Access Compliance Report Public Rights-of-Way (Curb Ramps)

Intersection ID: 2419 Main Street: LAUREL_RUN_DR Cross Street: WILDBROOK_DR Location: E

ADA ID: 8D2622353B48 Ramp Type: PerpDiag Initial Pass/Fail: Fail Overall Compliance: No Severity Score: 21.25

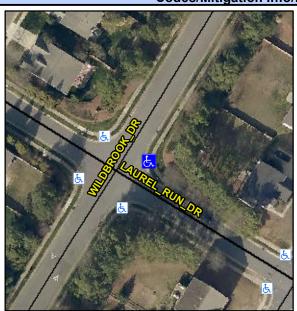
PROW/ADA:
R304.5.1, R304.2.2

Field Measurements/Component Compilance					
Compliance Description		Data	Compliance Description		Data
N/A	Ramp Length (in)	60.0	No	Ramp Slope (%)	9.1
No	Ramp Width (in)	36.0	Yes	Ramp XSlope (%)	1.9
N/A	Flare Type LT	N/A	N/A	Flare Type RT	N/A
N/A	Flare Slope LT (%)	N/A	N/A	Flare Slope RT (%)	N/A
N/A	Flare Traversable LT?	N/A	N/A	Flare Traversable RT?	N/A
N/A	Landing Length (in)	N/A	N/A	DWS Provided?	N/A
N/A	Landing Width (in)	N/A	N/A	DWS Contrast?	N/A
N/A	Landing Slope (%)	N/A	N/A	DWS Length (in)	N/A
N/A	Landing X Slope (%)	N/A	N/A	DWS Full Width?	N/A
N/A	Landing Curb? (Y/N)	N/A	N/A	DWS Offset (in)	N/A
N/A	Shared Landing?	N/A			
N/A	Gutter Ponding?	N/A	N/A	Gutter Slope (%)	N/A
N/A	Gutter Lip Ht (in)	N/A	N/A	Gutter X Slope (%)	N/A
N/A	Painted X Walk1?	No	N/A	Painted X Walk2?	No
	X Walk 1 Direction	To NW		X Walk 2 Direction	To SW
N/A	X Walk 1 Width (in)	N/A	N/A	X Walk 2 Width (in)	N/A
	X Walk 1 Slope (%)	0.4		X Walk 2 Slope (%)	0.7

WILDBROOK DR None LAUREL RUN DR StopSign Possible Solutions:
Remove & Replace Curb Ramp With Two New Directional Ramps or Equivalent.
